UNITED STATES PATENT AND TRADEMARK OFFICE

APPLICATION NO.	FILING DATE	FIRST NAMED INVENTOR	ATTORNEY DOCKET NO.	CONFIRMATION NO.
10/769,370	01/30/2004	Lloyd E. Andrews	2065/US/2	7913

Office Action Summary	Application No. 10/769,370	Applicant(s) ANDREWS ET AL.	
	Examiner Phil J. Kauffman	Art Unit 3652

DETAILED ACTION

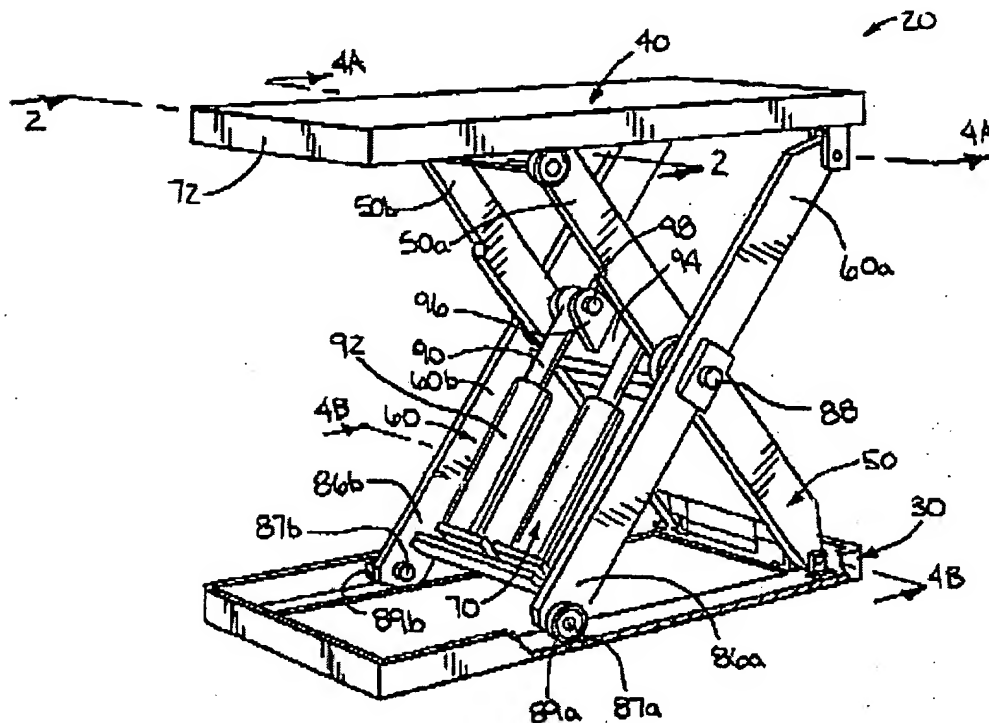
- a. Figure 30 shows scissor jacks 140 of trailer 124 in the extended position. Addressing the scissor jack in the front right of the figure, the lower end of the scissor jack cross member closest to the wheel 144 is fixed to the trailer, while the lower end of the other associated cross member is slideably engaged in track 172 of rail 170 atop bottom frame member 136. Both top ends of the cross members are fixed to top frame member 138, and there is no track 172 on the underside of top frame 138. The other sets of scissor jacks depicted are similarly secured. The scissor jack is immobile in this position and cannot move to the retracted position. In other words, the device is inoperable.

- b. In addition, please note, rail 172 can be seen atop bottom frame member 136 in figures 3, 4, 7, 10, 11, 13, 15, and 31. If a second rail 172 were mounted to the lower side of top frame member 138, it would be visible in these figures (the absence is most conspicuous in the last three figures listed).

- c. Paragraph 77 of the specification states "Since each scissor jack 140 has its own track 172 permitting free movement of the un-pinned ends, as shown in more detail in FIG. 25, each scissor jack can collapse to its retracted position without interfering with the other scissor jacks" [underlining added for emphasis]. In order to be operative, each scissor jack would require its own pair of tracks 172 (upper and lower) vice the track (singular) recited in the specification.

d. Below is an example of a scissor jack taken from US 6,974,123 B2 (Latvyns) show only to illustrate a functional version of a similar scissor jack. Please note the sliding connection on both the lower and upper surfaces.
